Access Compliance Report

Public Rights-of-Way

Intersection ID: 12274	Main Street: BERRYHILL_RD	Cross Street: MORTON_ST	Location: NW
ADA ID: 0F02BC836CF8	Ramp Type: BlendTrans2	Initial Pass/Fail: Fail	Overall Compliance: No
		Severity Score: 8.75

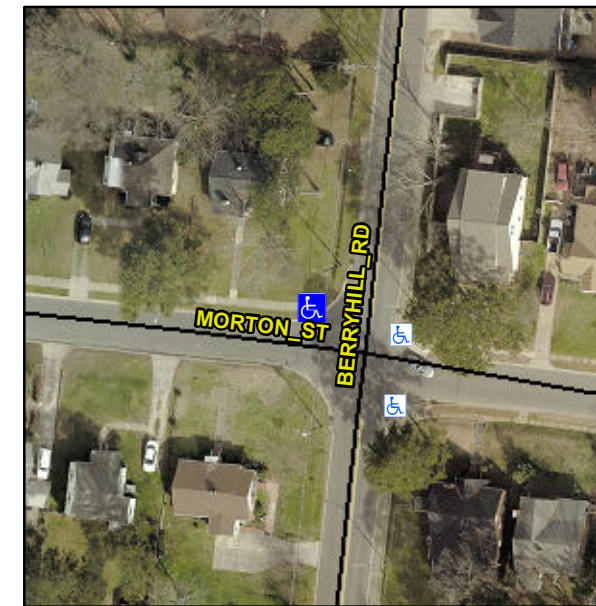
Not Found, R304.5.1

Compliance	Description	Data	Compliance	Description	Data
N/A	Ramp Length (in)	108.5	Yes	BlendTrans Slope (%)	2.6
No	Ramp Width (in)	47.0	Yes	BlendTrans XSlope (%)	1.9
N/A	Flare Type LT	N/A	N/A	Flare Type RT	N/A
N/A	Flare Slope LT (%)	N/A	N/A	Flare Slope RT (%)	N/A
N/A	Flare Traversable LT?	N/A	N/A	Flare Traversable RT?	N/A
N/A	Landing Length (in)	N/A	N/A	DWS Provided?	N/A
N/A	Landing Width (in)	N/A	N/A	DWS Contrast?	N/A
N/A	Landing Slope (%)	N/A	N/A	DWS Length (in)	N/A
N/A	Landing X Slope (%)	N/A	N/A	DWS Full Width?	N/A
N/A	Landing Curb? (Y/N)	N/A	N/A	DWS Offset (in)	N/A
N/A	Shared Landing?	N/A			
N/A	Gutter Ponding?	N/A	N/A	Gutter Slope (%)	N/A
N/A	Gutter Lip Ht (in)	N/A	N/A	Gutter X Slope (%)	N/A
N/A	Painted X Walk1?	No	N/A	Painted X Walk2?	N/A
	X Walk 1 Direction	To E		X Walk 2 Direction	N/A
	X Walk 1 Width (in)	N/A		X Walk 2 Width (in)	N/A
	X Walk 1 Slope (%)	1.3		X Walk 2 Slope (%)	N/A
	X Walk 1 X Slope (%)	6.4		X Walk 2 X Slope (%)	N/A

N/A	Ramp inside XWalk1?	N/A	N/A	Ramp inside XWalk2?	N/A
	Road Slope (%)	6.4		Clear Space?	N/A
	Road X Slope (%)	1.3	N/A	Clear Space to XWalk (in)	N/A
N/A	Any Obstructions?	N/A	N/A	Storm Grate/Utility Hazard?	N/A
	Obstruction Type			Storm Grate/Utility Type	
		N/A			N/A
			Yes	Surface Condition? (G/P)	Good
			No	Curb Slope (%)	9.8

Remove & Replace Curb Ramp With Two New Directional Ramps or Equivalent.
